---STAFF REPORT---

ITEM: Delray Medical Center – Class IV Site Plan Modification, Landscape Plan, and Architectural Elevations Associated with the Construction of a 38,250 square foot radiation therapy building.

DELRAY BEACH RADIATION THERAPY CENTER PREPARED FOR PROTON INTERNATIONAL/HTI CANCER CENTERS CITY OF DELRAY BEACH FLORIDA		SHEET NUMBER 02.00
OVERALL SITE PLAN		
PROFESSIONAL ENGINEER STATE OF FLORIDA MICHAEL SCHWARTZ No. 56200 Kimley-Horn		
REVISIONS NO. DATE BY	REVISIONS NO. DATE BY

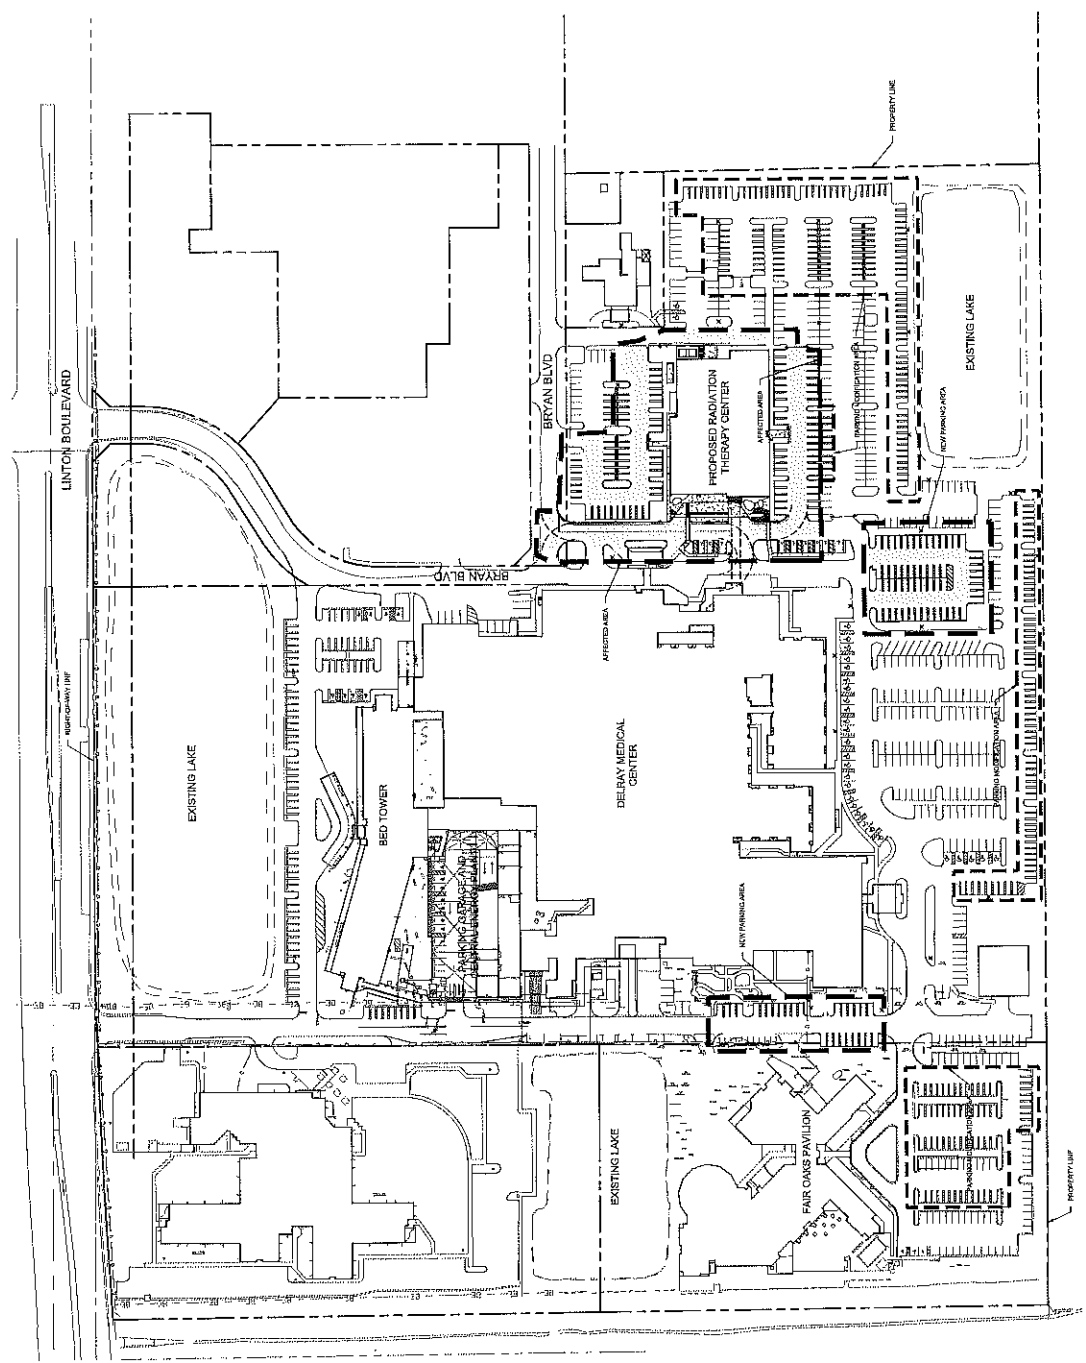
Technical Items: While the revised site plan has accommodated most of the staff concerns, the following items remain outstanding, and will need to be addressed prior to certification of the site plan unless as otherwise stated:

1. Palm Beach County Health Department permits required for this project. Permits will have to be phased in accordance with construction phasing so Health Department releases do not hold-up Certificate of Occupancy issuance by the Building Permit Department.
2. Provide signed and sealed drainage report indicating the proposed system's ability to meet storm water quality and quantity requirements in accordance with the South Florida Water Management District regulations per LDR Section 2.4.3 (D) (8). In addition, the surface water management system needs to be designed in accordance with LDR Section 6.1.9 for a minimum of a 10 yr./24 hr. storm event. The system needs to provide for positive drainage of lots, streets, roads, and other public areas as well as handling any run-off from adjacent areas that historically flowed into the subject area. Include drainage calculations confirming

that there will be no negative post development impacts on adjacent homes, structures or properties.

3. Revise fire suppression water line design. As discussed on Wednesday July 6th, 2016, move backflow preventer closer to bldg. with bollards.
4. Minimum size of water main in City of Delray Beach is 8-inches per LDR Section 6.1.10 (B). Material of proposed water main is to be Ductile Iron or C-900, refer to city details. Revise plans accordingly.

5. Provide double valves at connection points for new mains to existing mains.
6. Provide 12' wide exclusive sewer easement up to first cleanout if cleanout is not within 18" of right-of-way or existing sewer easement.

7. Provide signed and sealed calculations indicating current and proposed estimated flows into existing sanitary sewer system; submit to the attention of the Engineering Division. Upon review and approval, a letter from the Deputy Director of Public Utilities stating that the City's system has sufficient capacity to treat proposed flows will be issued. This is a requirement in accordance with LDR Section 5.3.3 (D) for the Off-Site Impact Assessment to the City's water and sewer systems.

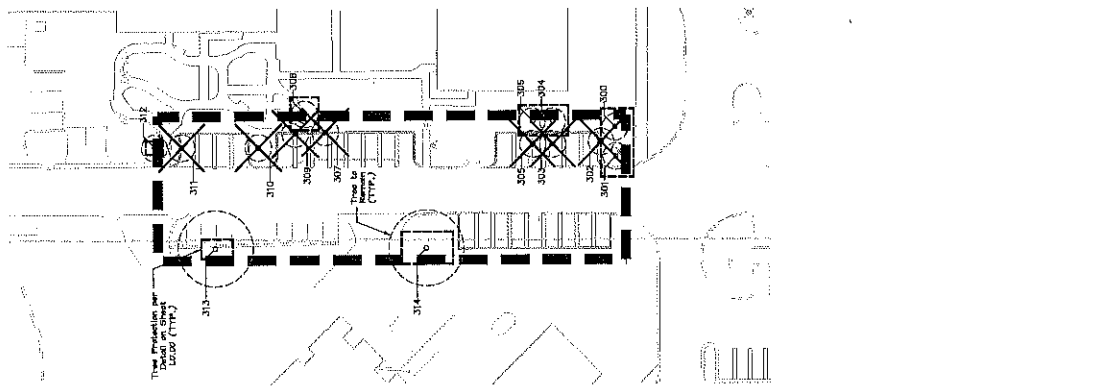
The new landscaping consists of Hong Kong Orchid trees, Gumbo Limbo trees, Southern Live Oak trees, Royal Palms, Montgomery Palms, and Mexican Fan Palms. The landscape areas will be under planted with Pitch Apple, Auntie Lou Ti Plant, Queen Emma Crinum, Red Tip Cocoplum, Croton, Green Island Ficus, Dwarf Podocarpus, Pink Muhly, Blueberry Flax Lily, and Dwarf Schillings Holly. The proposed landscape plan complies with the City's Land Development Regulations (Section 4.6.16) except the internal landscape areas identified below. However, the development plan identifies numerous trees that will be removed. These are comprised primarily of Live Oak trees. To the greatest extent possible, these trees should be relocated on the property. Consequently, a condition of approval is attached that a certified arborist report be submitted regarding the viability of relocating the native trees to other areas of the property and replace the proposed oak trees in the area of the proposed building.

- 1. That a certified arborist report be submitted regarding the viability of relocating the native trees to other areas of the property and replace the proposed oak trees in the area of the

proposed building prior to site plan certification. The relocation of these trees shall be subject to the approval of staff.
